**AGENDA**  
**ARCHITECTURAL REVIEW BOARD MEETING**  
**City Hall, 385 South Goliad, Rockwall, Texas**  
**Council Chambers Conference Room**  
**January 31, 2017**  
**4:00 P.M.**

# CITY OF ROCKWALL PLANNING AND ZONING COMMISSION MEMO

**AGENDA ITEM:** **SP2016-034;** PD Site Plan for a Grocery Store.

## City of Rockwall Project Plan Review History

SHEET NUMBER: SP-1

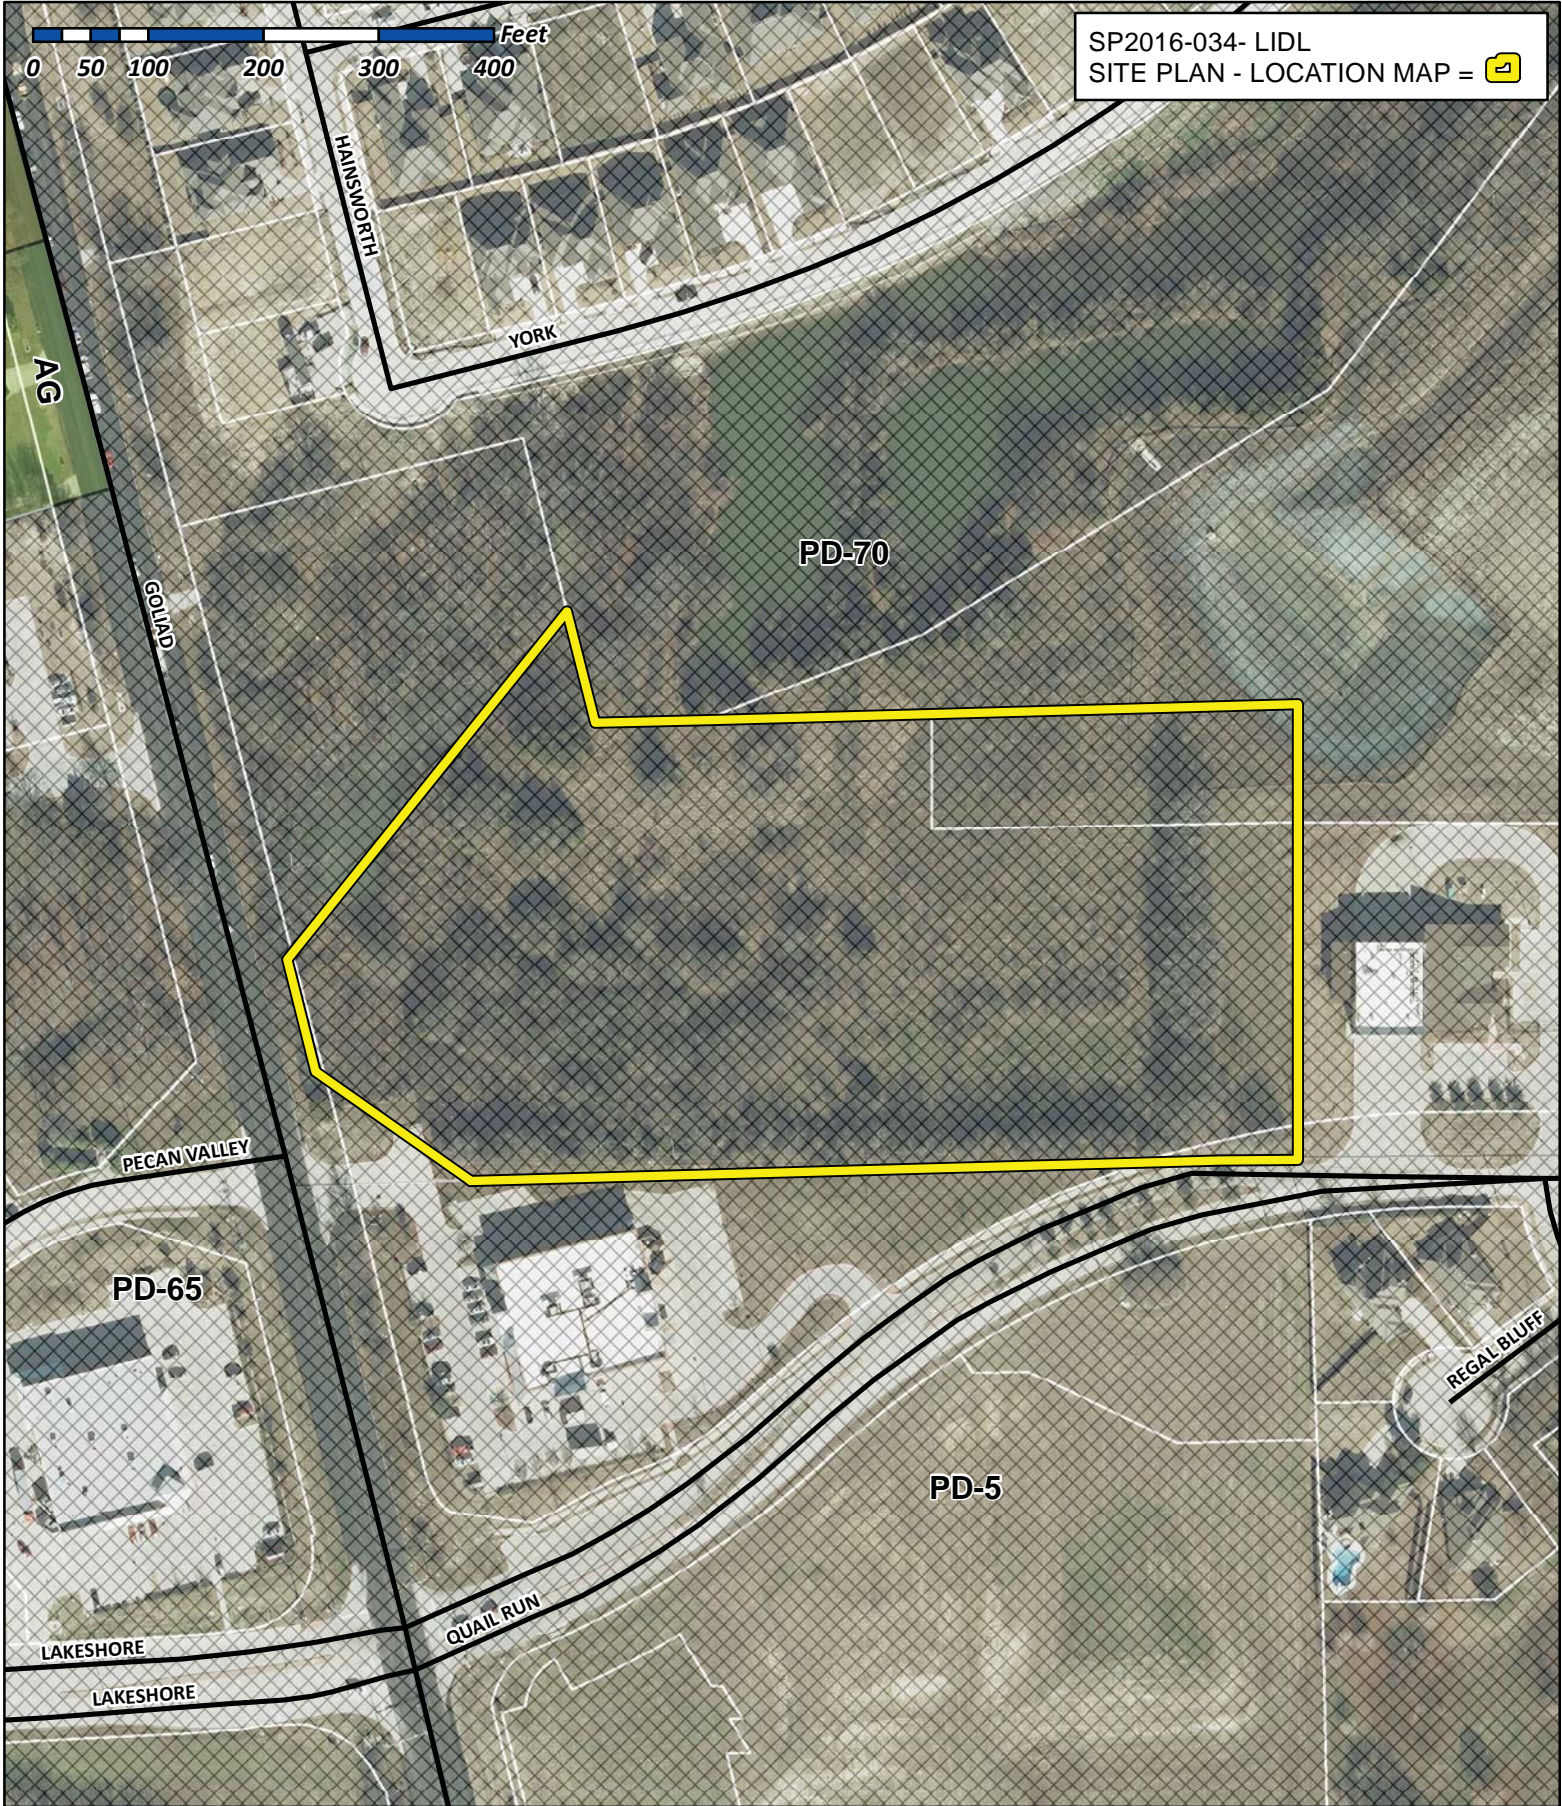
1. Relabel title as "PD Site Plan"

Type of Review / Notes	Contact	Sent	Due	Received	Elapsed Status	Remarks
2. Provide PD Development Plan elements on site plan (e.g. pedestrian orientation & accessibility, walking path, proposed access points to the site, tree & floodplain preservation, etc.)

3. Indicate and label firelane and access as: "24-ft Firelane (minimum), Utility, and Public Access Easement" or as appropriate.						
4. Truck loading dock and dumpster are not to face a public street. Requires approval by the Planning and Zoning Commission.						
<b>Building Elevations:</b>

**LP 1.01**

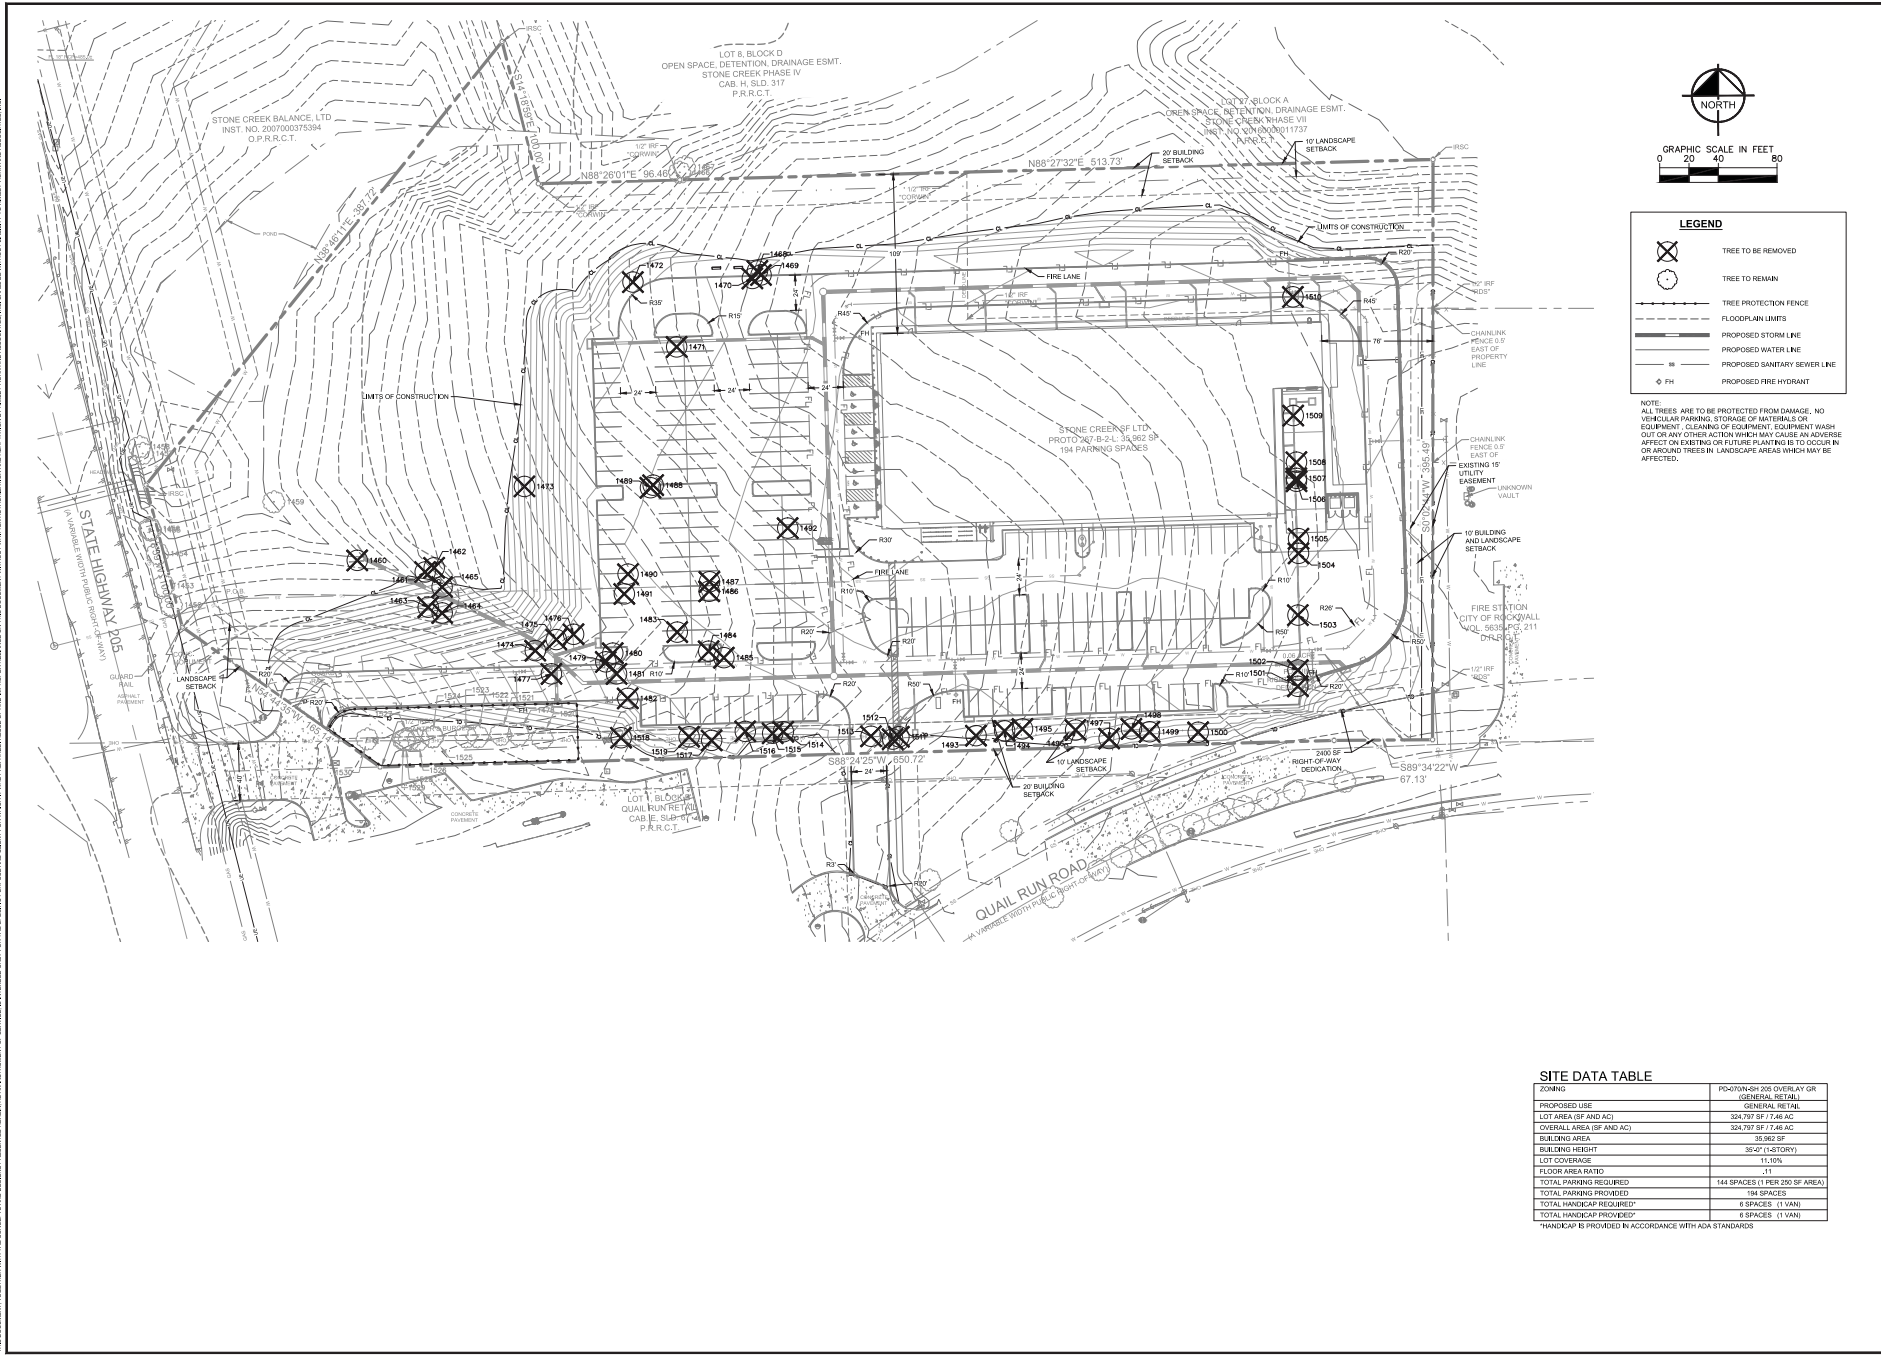
5. Provide a materials samples board for the ARB review.						
<b>Landscape Plan:</b>						
1. Provide Sod in area's labeled as "seed" and remove the label "seed". Disturbed area's require erosion control prior to release of CO (see Engineerings standards of design).

2. Correct "Planting Notes" #9 by removing the words "grass seeding" from the statement.						
<b>Photometric Plan:</b>						
1. The lighting pole standards are not to exceed a maximum overall heightof 20-ft (includes pole, base, or combination thereof) per the PD Ord. standards. Provide detail for pole standard. 2. Provide cut sheets for all exterior lighting fixtures.						
The following are scheduled meeting dates that you and/or your representative(s) should attend regarding the PD Site Plan. If you have any quesitons regarding this case, please feel free to contact David Gonzales, AICP with thePlanning Department at 972-771-7745.						
<b>Meeting Dates to Attend:</b>						
Architectural Review Board: December 27, 2016 (5:00 p.m.) [applicant to receive recommendations from ARB]						
Planning - Work Session: December 27, 2016 (6:00p.m.) [applicant to present case to P&Z for discussion].
